Customer Services Bulletin

TB-M-0049

External gas BBQ point ventilation - Product Modification Notice

MODEL: All Alliance SE motorhome models

Step 1

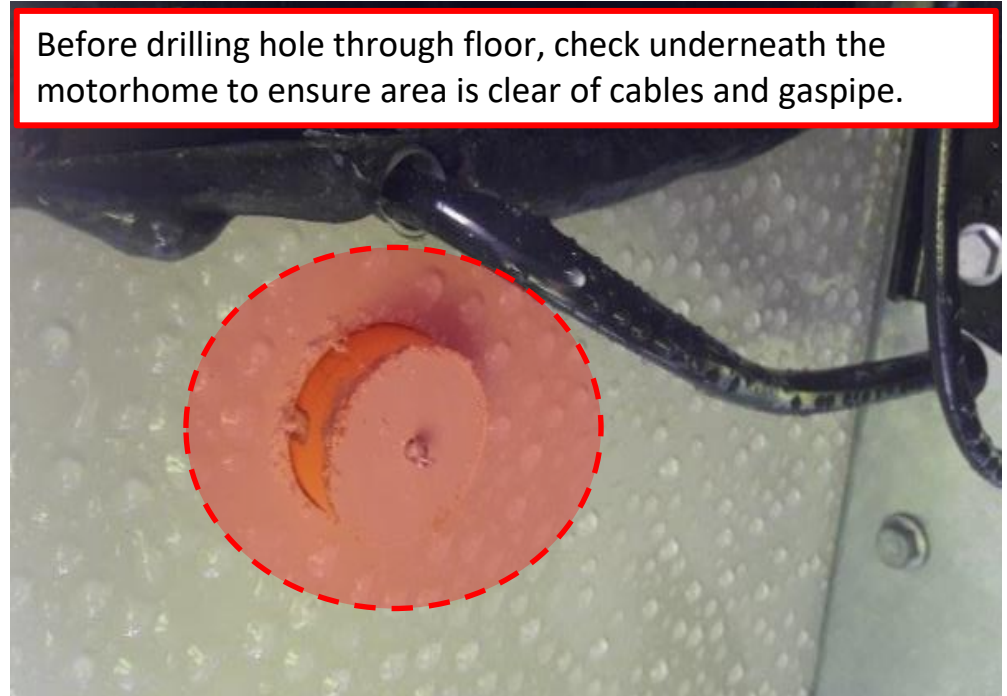
Using appropriate model document set, prepare to drill 57mm dia hole though the floor close to the gas BBQ supply pipe. Check you have adequate access, on some models it may be necessary to remove panels or fixings first. Also check under the motorhome in the area the hole will be cut, see picture to right.

Before drilling hole through floor, check underneath the motorhome to ensure area is clear of cables and gaspipe.

Step 2

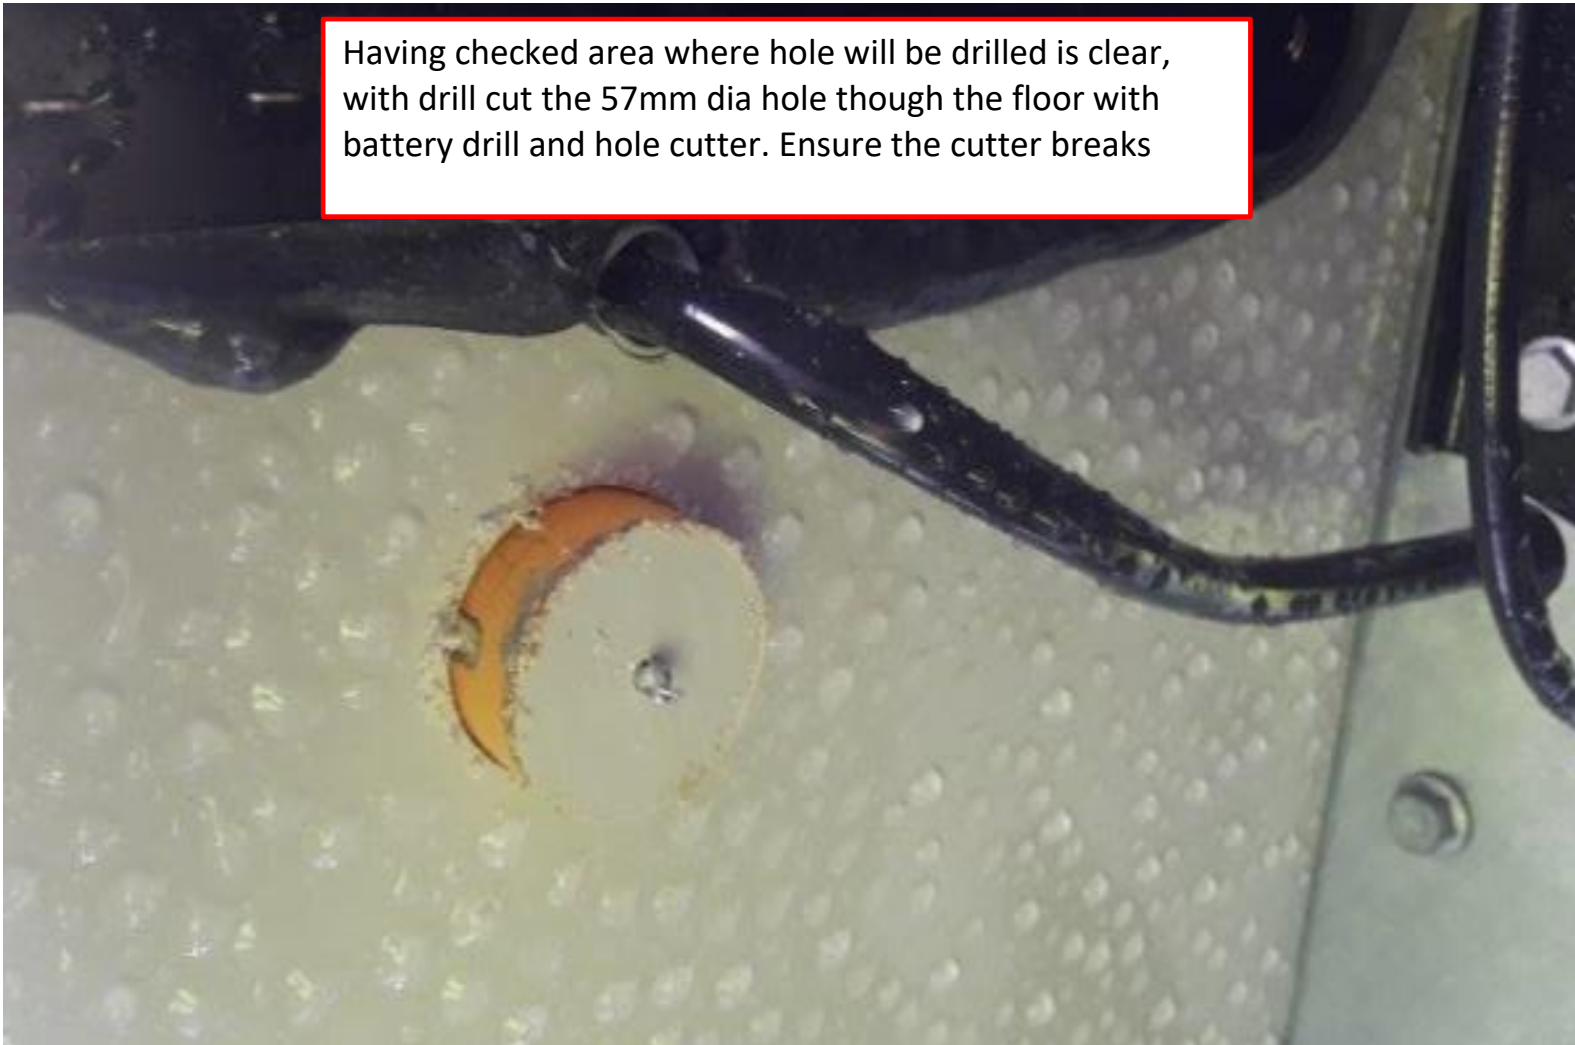
Having checked area where hole will be drilled is clear, with drill cut the 57mm dia hole through the floor with battery drill and hole cutter. Ensure the cutter breaks
